BOROUGH OF OCEANPORT

PLANNING/ZONING BOARD

AGENDA • SEPTEMBER 8, 2020

Re: Preliminary and Final Site Plan
Block 127, Lot 4
MPCC II, LLC
2 Crescent Place
Borough of Oceanport, Monmouth County, New Jersey
MC Project No. OPP-268

C-5

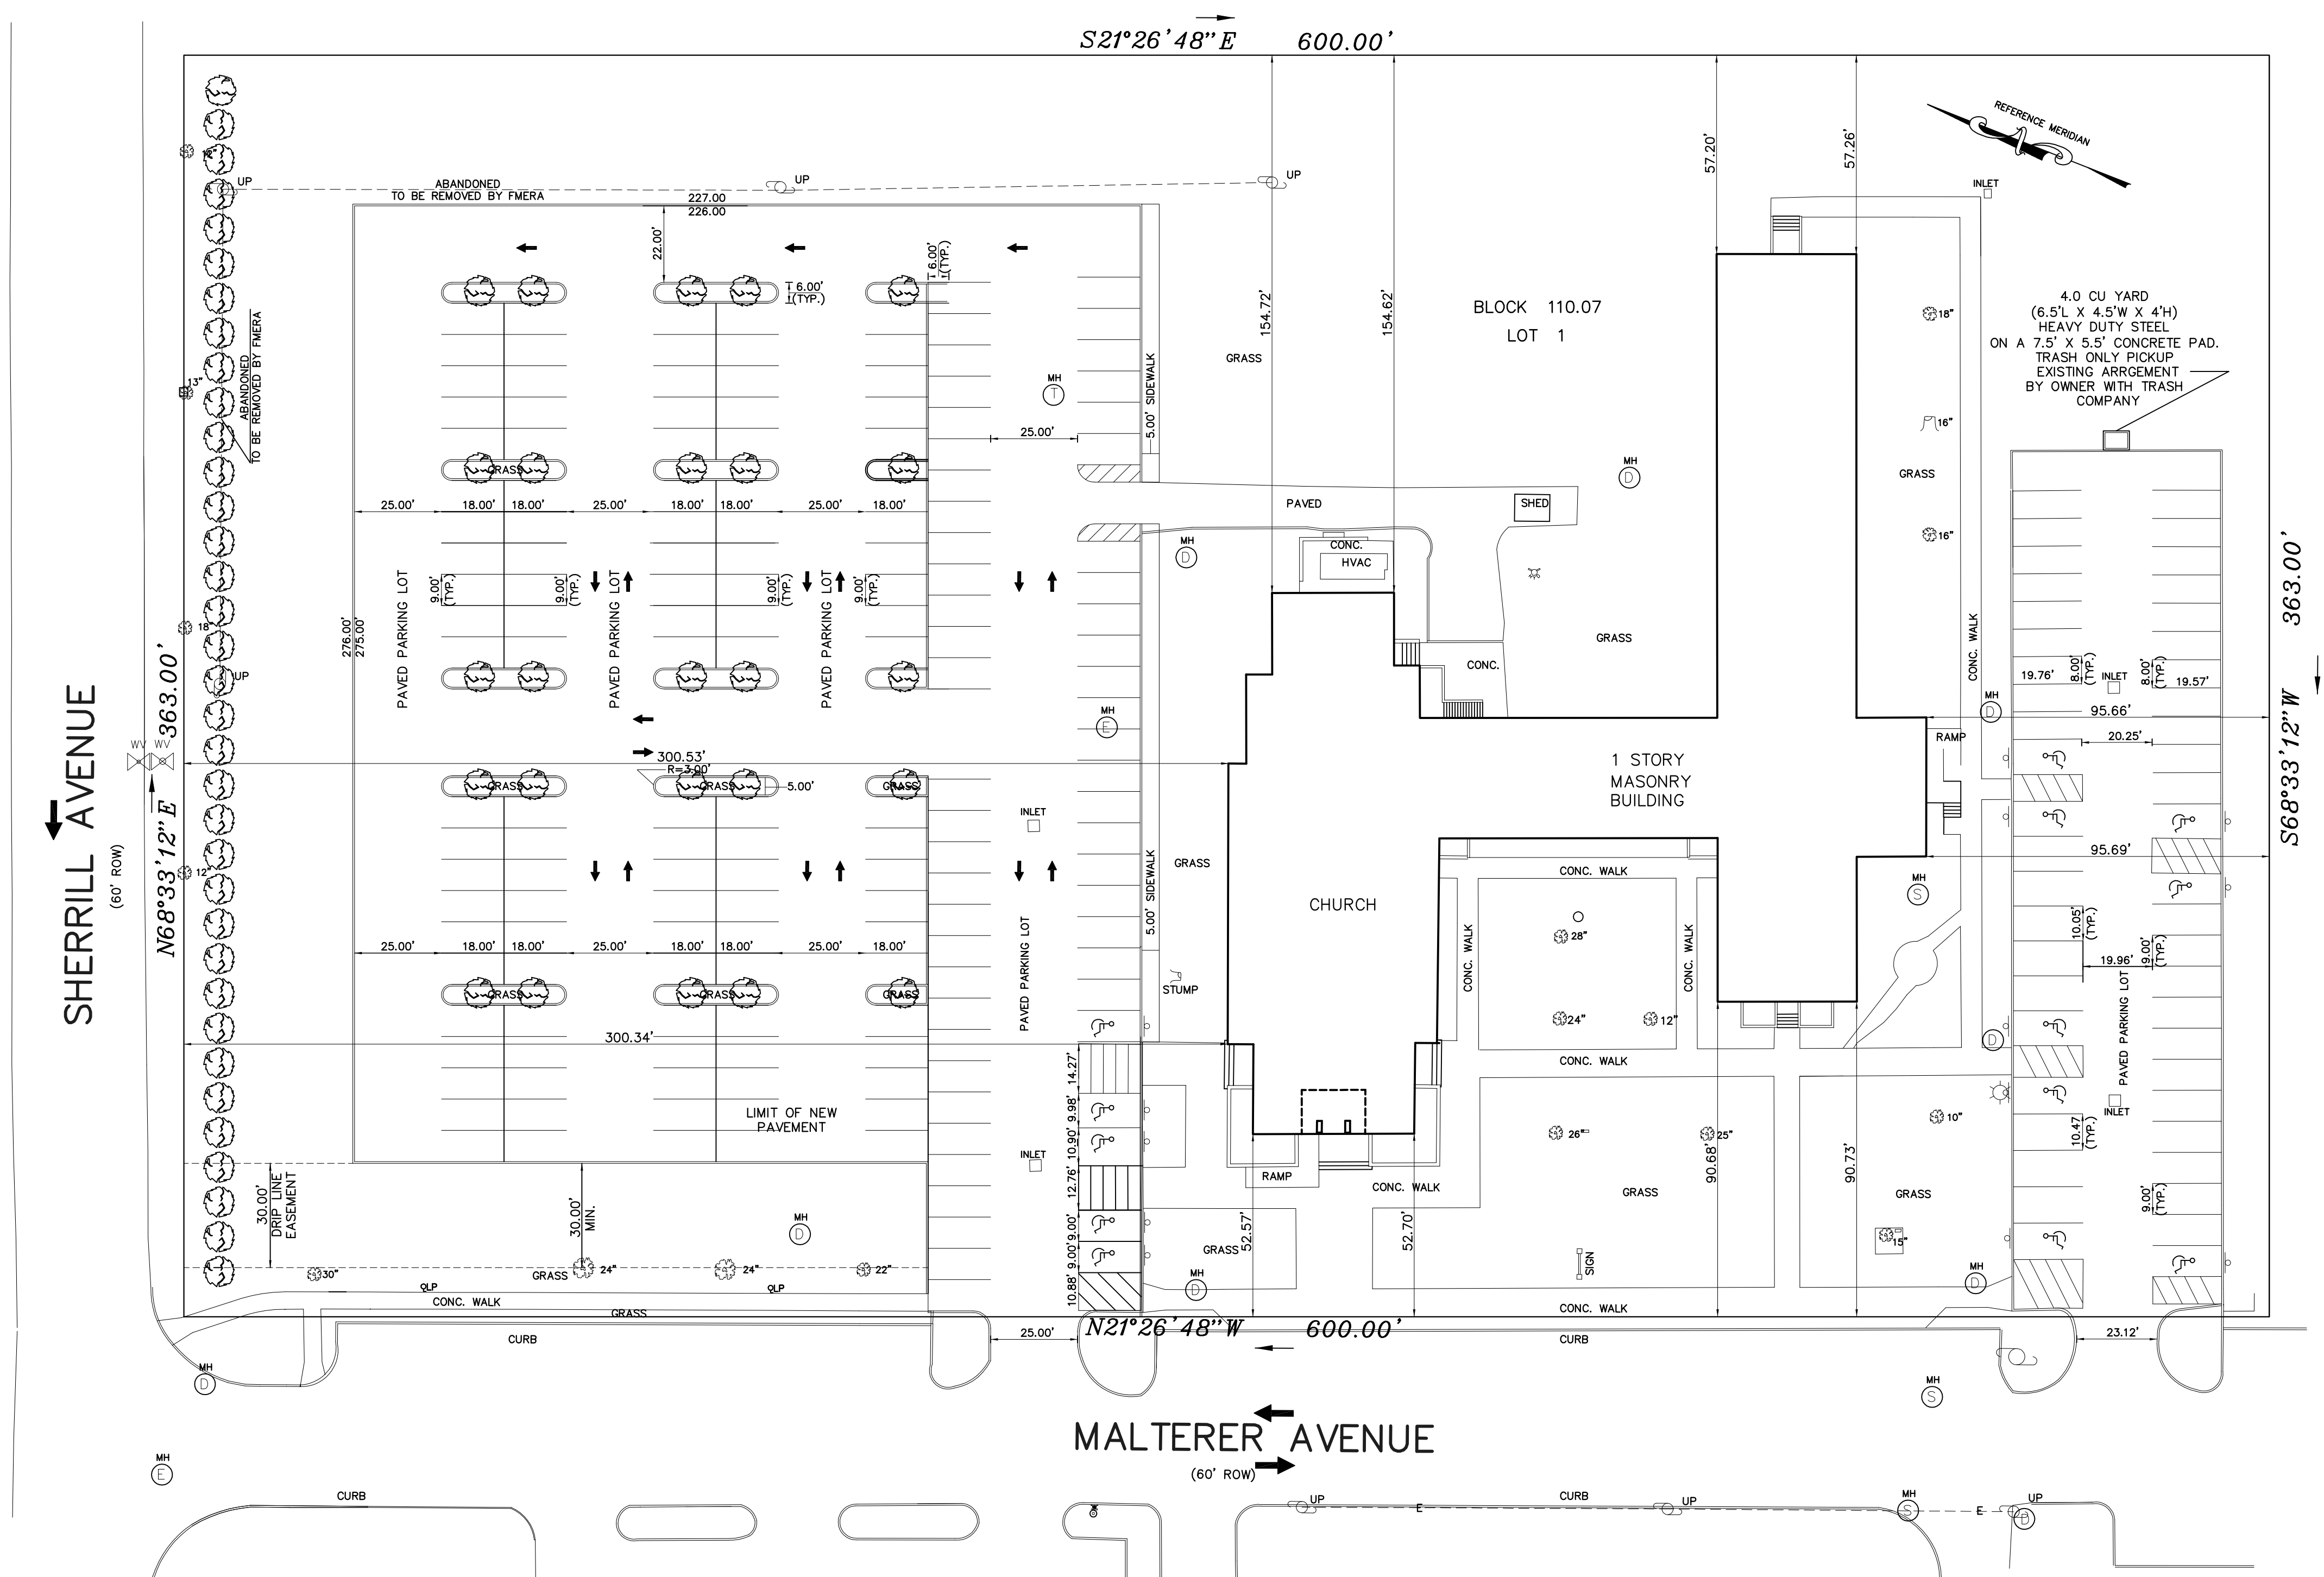
2. The project is a major project per the information provided on drawing C-5, the stormwater design needs to comply with N.J.A.C. 7:8. Subchapter 5.
 3. The applicant shall submit a Stormwater report describing the existing and the proposed conditions signed and sealed by New Jersey Licensed Professional Engineer. The water quality storm routings and the selection of BMP device to treat water quality storm per NJAC 7:8 -5.5. must be included within the report.
